From: Jill Marsland
Sent: 4/02/2025 9:31:36 AM
To: Council Northernbeaches Mailbox
Cc: Grant Christmas
Subject: TRIMMED: Submission in relation to Modification Application 2024/ 0700 - No. 3 Summit Ave, Dee Why
Attachments: Ltr - Northern Beaches Council - Submission re Mod2024-0700 - 04-02-25.pdf;

YOUR REFERENCE: MOD2024/0700
PREMISES: 3 SUMMIT AVENUE, DEE WHY

Figure 1: The Consent plans show the existing deck at RL 56.300 on the western elevation. This is a height of 300mm above the Boundary Wall, which is shown at RL 56.000.

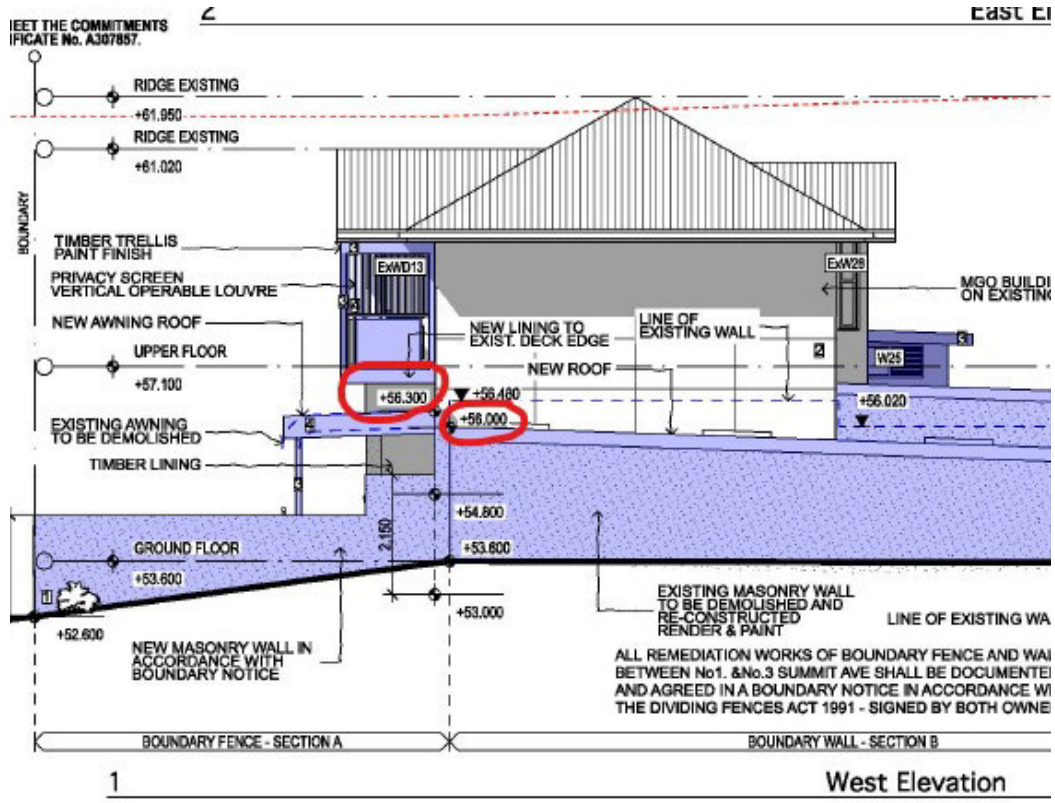
4. Our Client's submission is in regard to a pre-existing deck, which has now been demolished, located on the northern elevation at No. 3 (**Deck**). The side of the Deck, as shown on the western elevation, was observed from our Client's home. The Deck is shown at a height of RL 56.300 on the stamped approved plans for the original consent DA2018/0383 (**Consent**): see Figure 1.

5. The Deck is shown on the western elevation at a height of 300mm above the Boundary Wall, which is shown at RL 56.000.
6. The Consent provided for “New Glass Balustrade To Existing Deck” And “New FC Lining To Underside Of Exist. Deck”: see Figure 2.

Figure 3: Modification Application 2024/0094 changed the new balustrade from glass to metal, and added the notation “Deck timber appearance”. It is not clear why these changes are not clouded. The Deck is consistently shown at RL 56.300.

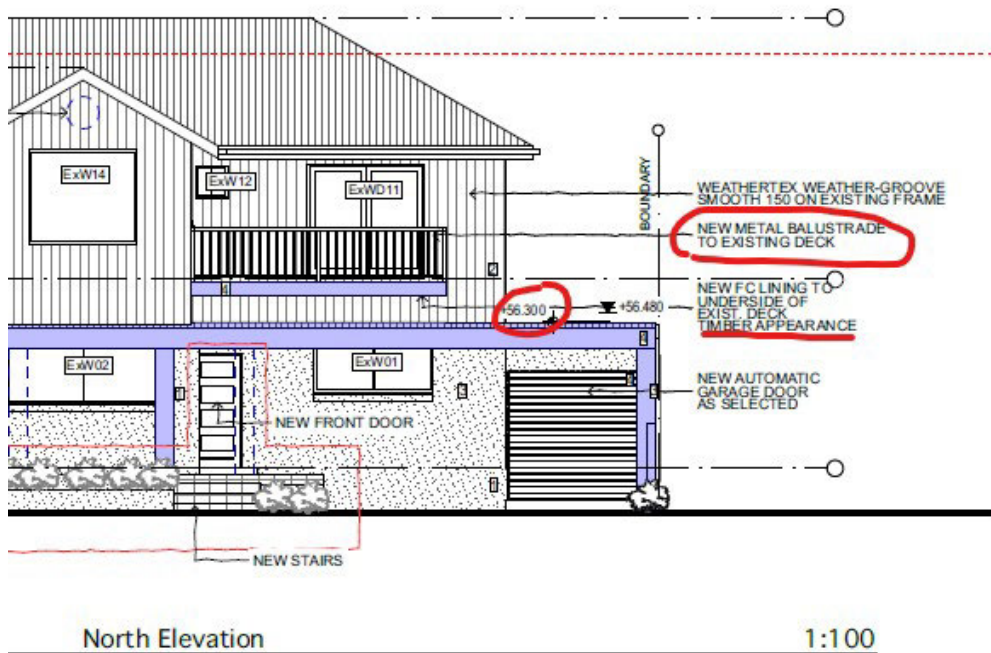
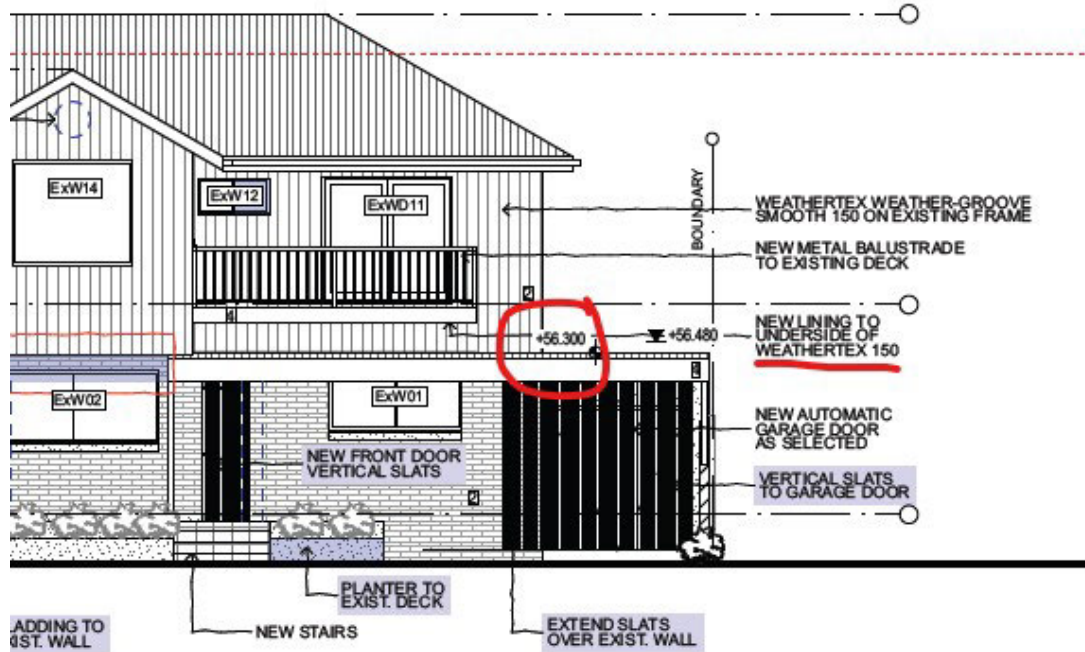
7. Modification Application 2024/0094 showed the change from a new glass balustrade to a new metal balustrade. It also added “Deck timber appearance” to the new FC lining to underside of existing deck: see Figure 3.

Figure 6: The Modification Application shows a 250mm eave overhang on the first floor.

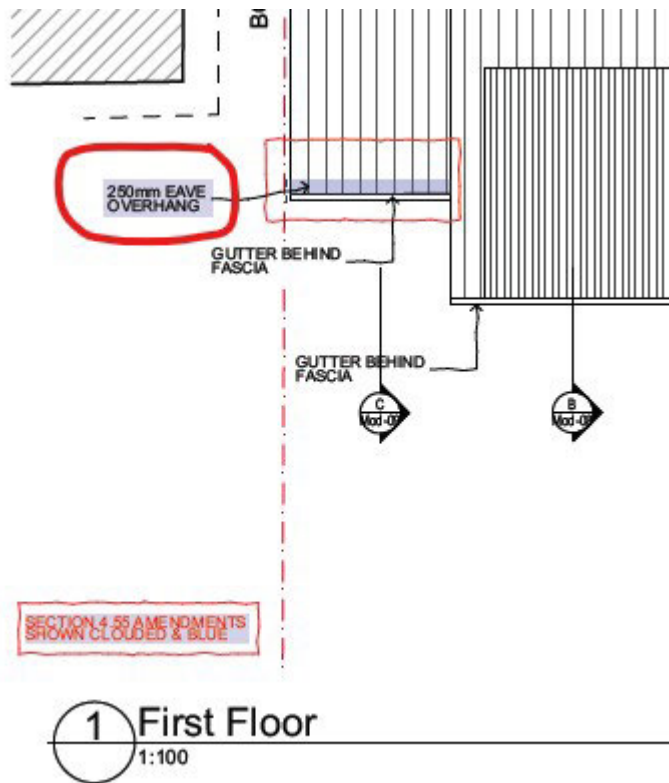
10. The lack of any detail as to why the Deck has been demolished without consent, and a new deck is now being constructed at a higher level than shown on the plans should cause Council to issue a Stop Works Order pursuant to Schedule 5, Part 1, item 2 of the *Environmental Planning and Assessment Act 1979*.
11. The First Floor Plan (Drawing No. Mod-04 Rev B prepared by Grant Seghers Design dated 18 December 2024) shows a 250mm eave overhang. Our Client is concerned about this overhang, and wants clarification to ensure that it will not in any way cross his boundary line: see Figure 6.

Figure 7: The West Elevation includes a notation that the awning is to be maintained | re-built square. This notation lacks clarity and certainty.

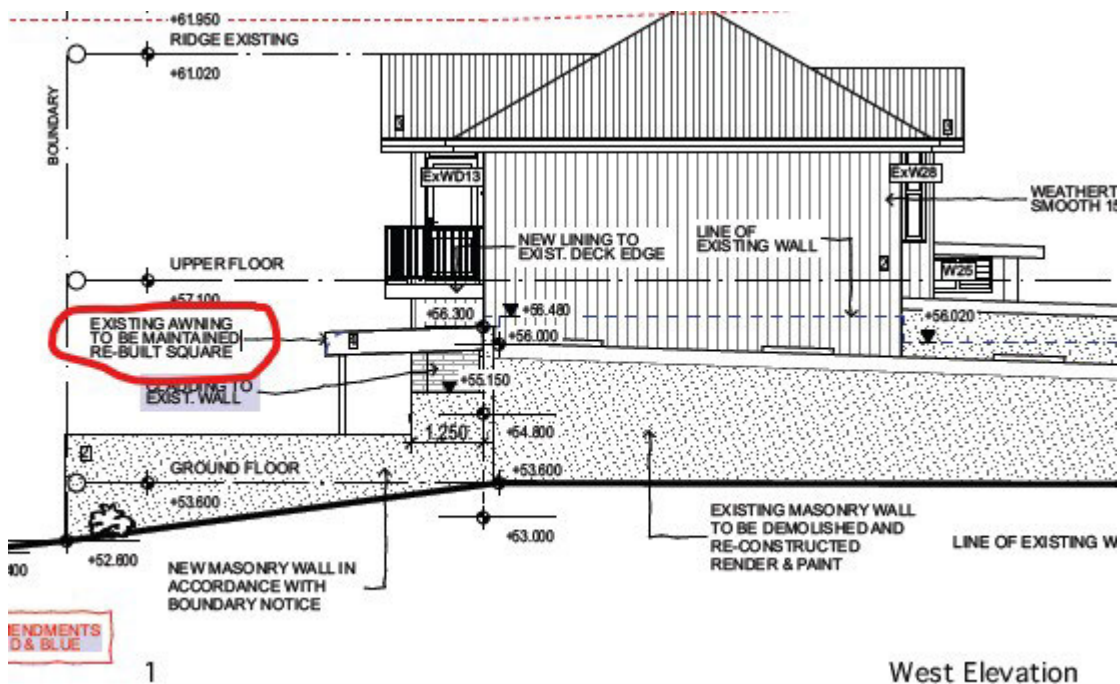
12. The Modification Application is unclear as to whether the existing awning on the northern elevation is to be maintained or to be demolished and rebuilt square: see Figure 7. The West Elevation includes a notation that is unclear. As such, our Client is unable to ascertain the potential impacts, if any, to his property.
